HCAAC objection to application [HGY/2023/1327](#) for 17 Denewood Road, N6 4AQ

IMAGE 2: PHOTO OF FRONT

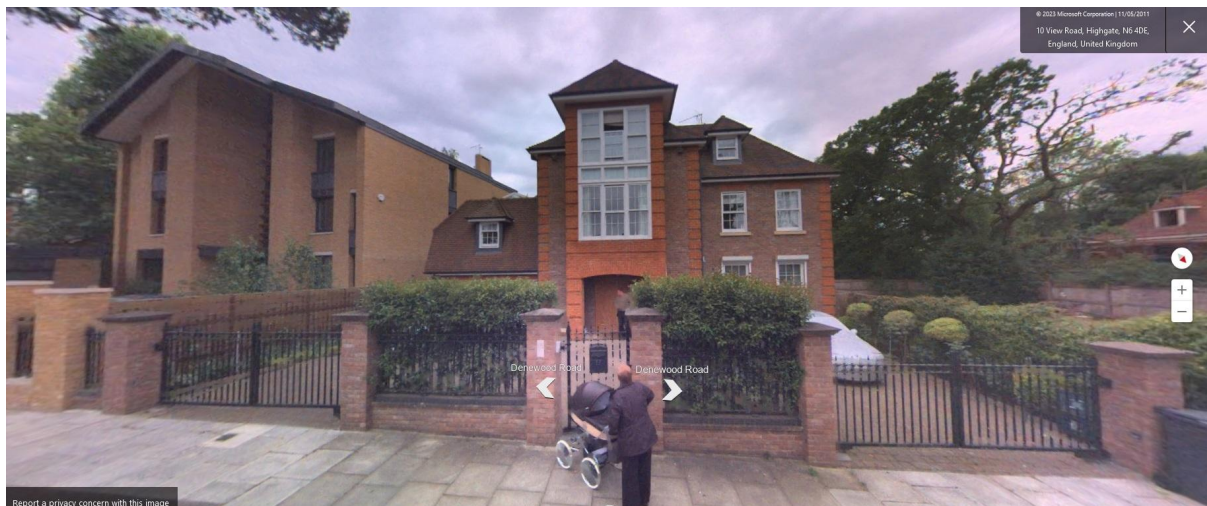
It is not possible to get a clear view of the house currently due to the hoardings around the property, and the house has been blanked out in every Google Streetview image available online. However, it is clear that “IMAGE 2: PHOTO OF FRONT” in the D&A for this application is not consistent with the appearance of the house taken from Bing maps “Streetside”:

The image above from the D&A is also not consistent with application drawing “BDH222(PL)024.1_01-Existing Street Elevation.pdf”.

The D&A image above also shows a house to the right of No 17 which does not exist in reality. The most recent planning permissions for No 19 date from 2006/7. Planning permissions [HGY/2007/0607](#) and [HGY/2007/0608](#) concerned building a block of flats but the building in the above image appears to be a house. Does the image from the D&A show a house which was demolished years ago? Are those permissions still valid? Three objections to tree application [CON/2020/0235](#) and the report from Haringey’s own tree officer asked about the status of No 19 as “a development site”, but no answer was forthcoming. No 15 also looks different.

Also, is the boundary between Nos 17 and 19 as shown by the fence on the right in the D&A image closer to the flank wall/corner of No 17 than in the Bing image?

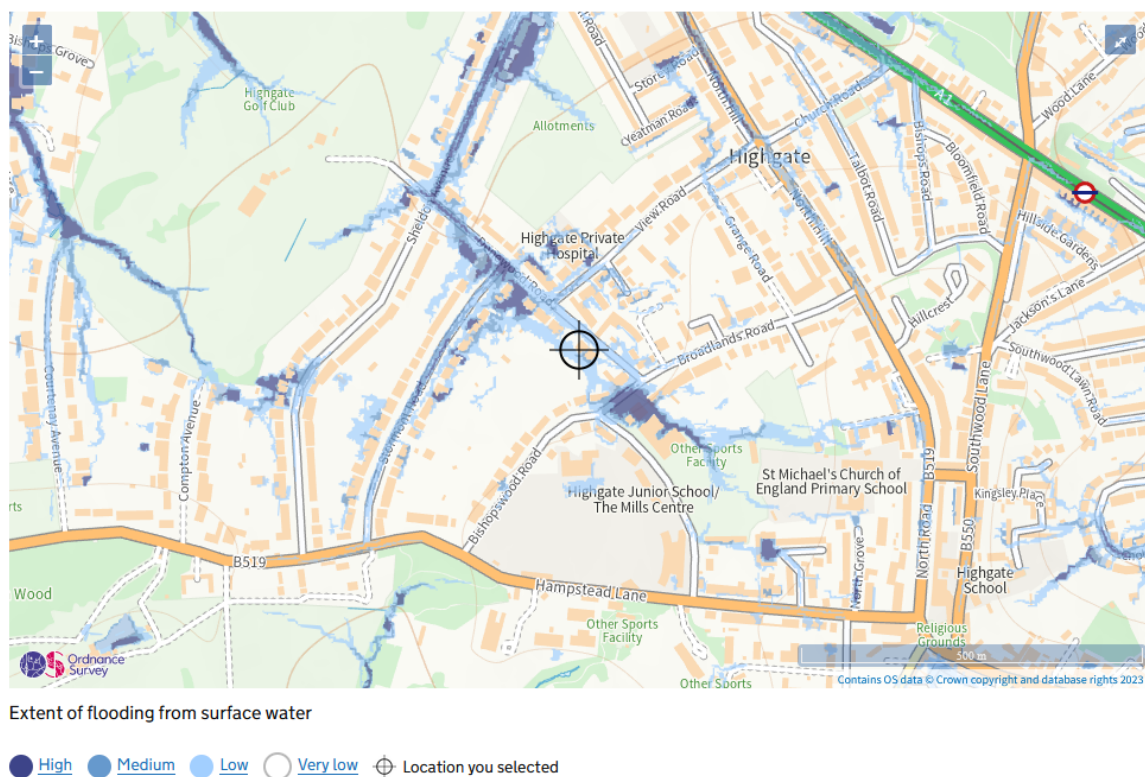
The large area of paving should be SUDs, and ideally reduced, with the former degree of planting reinstated or increased to improve sustainability performance.

While No 17 is only at medium risk of surface water flooding, areas closeby in both directions are at high risk. Making surfaces more permeable should be a priority.
